## Water Resources Department

Re: Morgan Lake (M-64) – Inspection Summary

Upstream face indicating current and minimum freeboard has been adequate

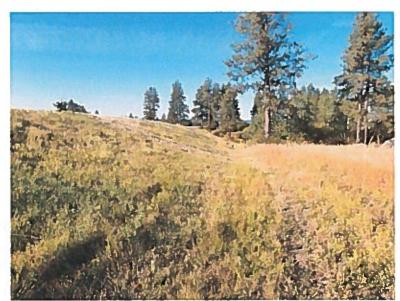
The reservoir level was 6.6 feet below the dam crest when inspected. Minimum freeboard was 4.2 feet, which is adequate. The pine tree near the toe of the dam has been removed and the dam has a well maintained cover of grass. The grass cover on the dam effectively reduces surface erosion and provides very little cover for burrowing animals. However, there was minor vegetation on the upstream face of the dam. Although this vegetation has not yet become a dam safety issue, regular clearing will prevent these dam safety issues from becoming more serious in the near future.
